RFQ NUMBER
DEFK10002

DEFK10002: Tri-State AFRC Addition and Renovation, Kenova, WV

ADDENDUM NO. 1 August 19, 2009

**RENOVATIONS & ADDITIONS TO THE
ARMED FORCES RESERVE CENTER
TRI-STATE AIRPORT
KENOVA, WEST VIRGINIA**

ADDENDUM NO. 1	DRAWING NO. SKES.2.1
SCALE NTS	SHEET NO. ES.2
DATE 08/21/09	
DRWING EDC

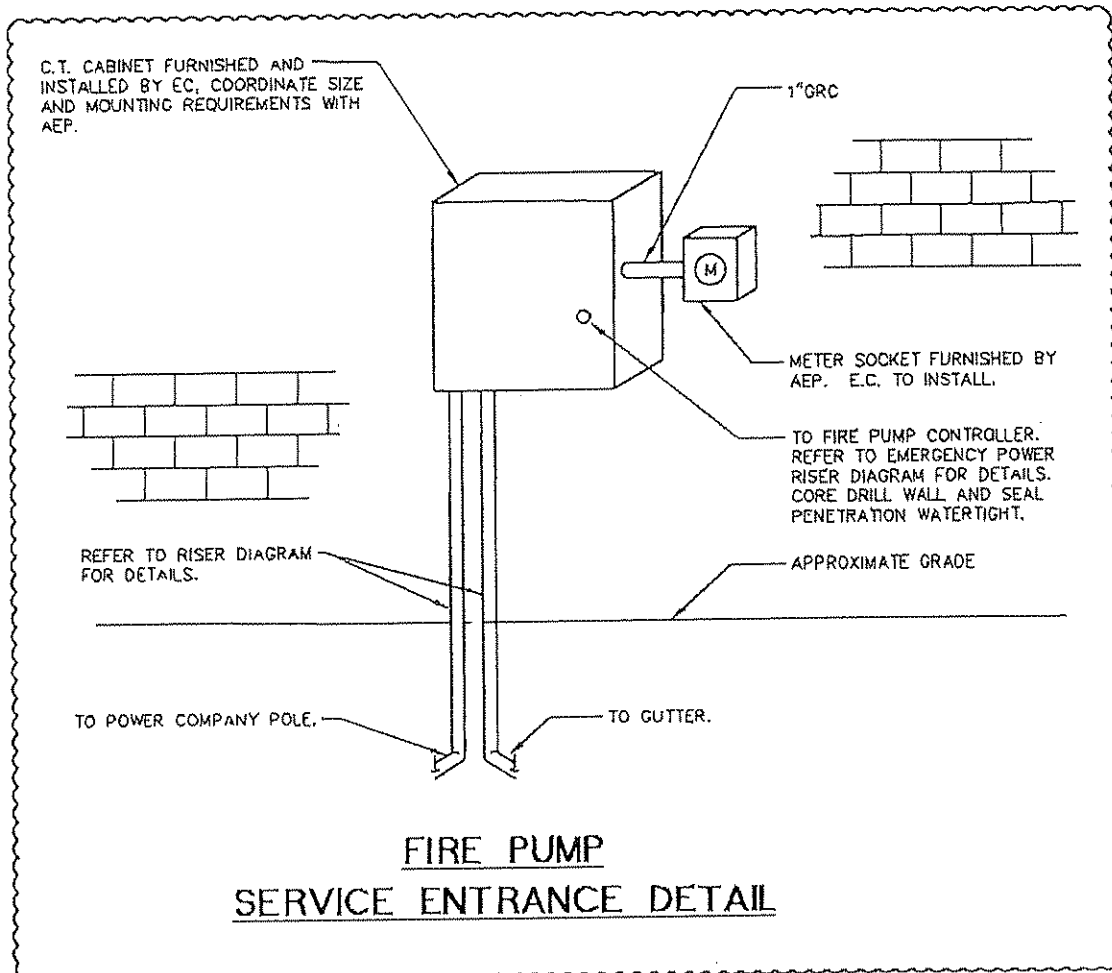
Item #, ES.2, Site Plan Details– Base Bid – Electrical:

- a. Refer to attached sketch SK.ES.2.1. This detail shall replace Metering and Pedestal Plan and Elevation currently on ES.2.

ADDENDUM NO. 1	SHEET NO. SKE4.0.1
SCALE NTS	SHEET NO. E4.0
DATE 08/21/09	
DRAWN EDC

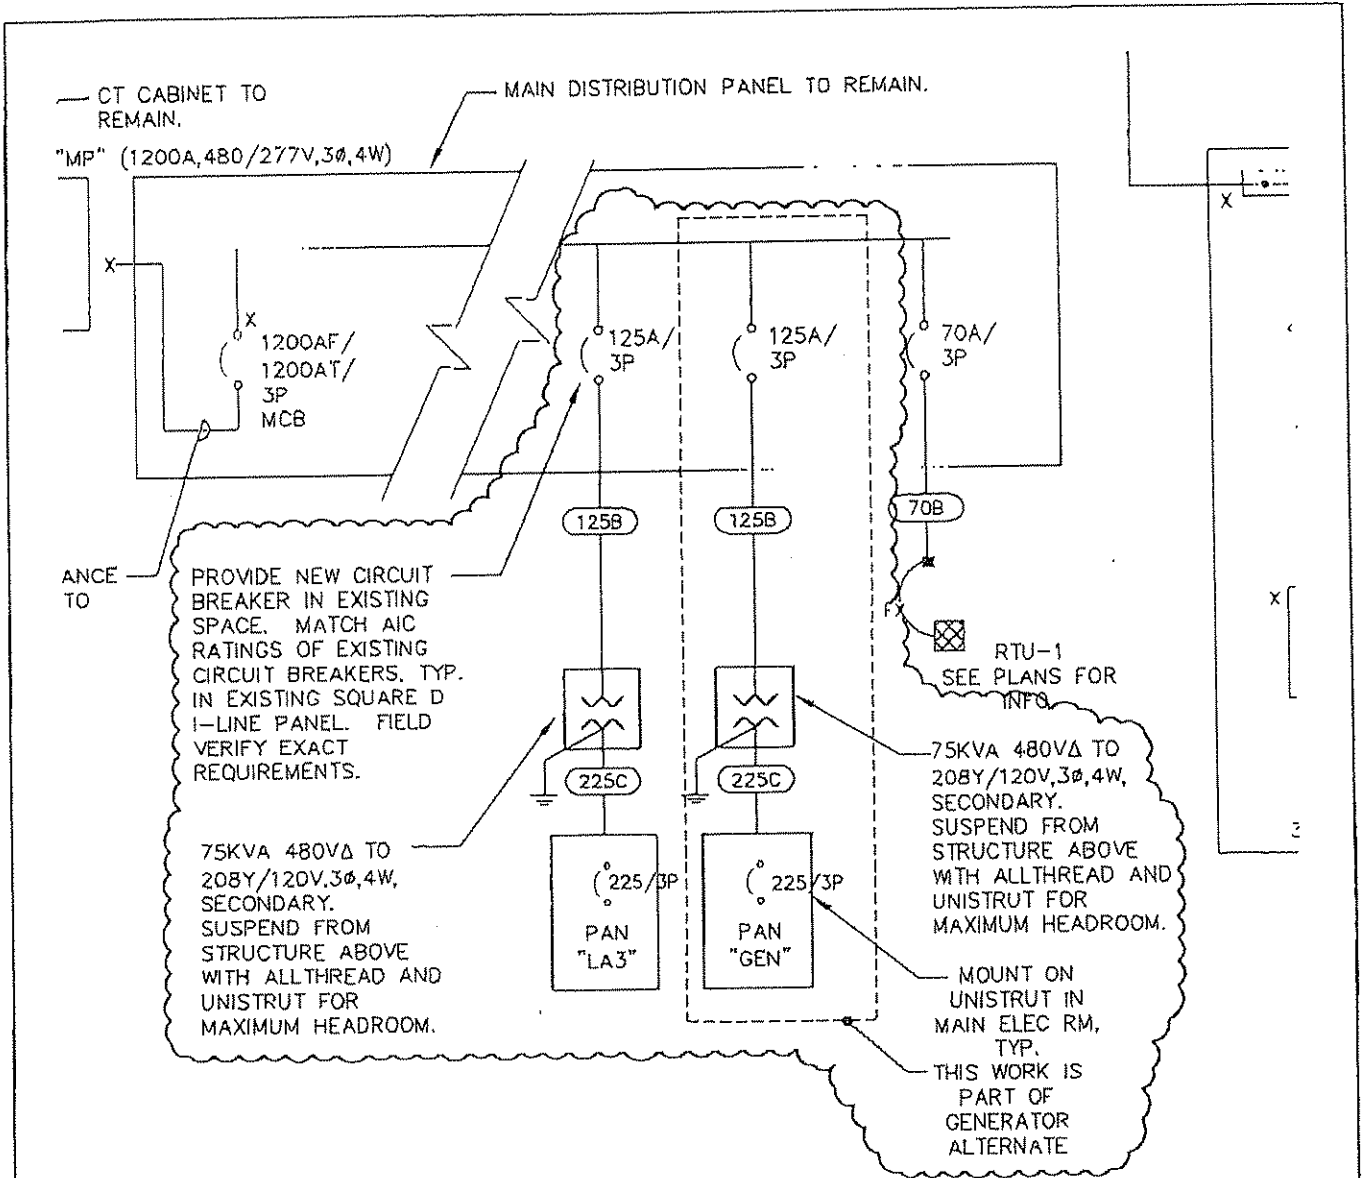
Item #. E4.0 Base Bid New Work/Demo Riser Diagrams and Schedules:

- a. Refer to attached sketch SK.E4.0.1.
- b. Panelboard Schedule, revise Panelboard designation from "LA2" to "LA3."
- c. Revise panelboards "LA3" and "GEN" to be 225a/3p main circuit breaker in lieu of main lugs.

- a. Demolition riser diagram - service entrance conductors shall be removed.
- b. Generator wiring diagram note #2, revise voltage of block heater 208v, 1phase.
- c. Generator wiring diagram note #8, revise generator cabinet unit heater to 5kw, 208v,3phase.
- d. New work riser diagram, disconnects feeding fire pump equipment shall both be nema 3r.
- e. Provide 1"grc for meter socket cabling.
- f. Refer to attached sketch SK.E4.0.1 for work related to adding panelboard for ancillary generator loads.
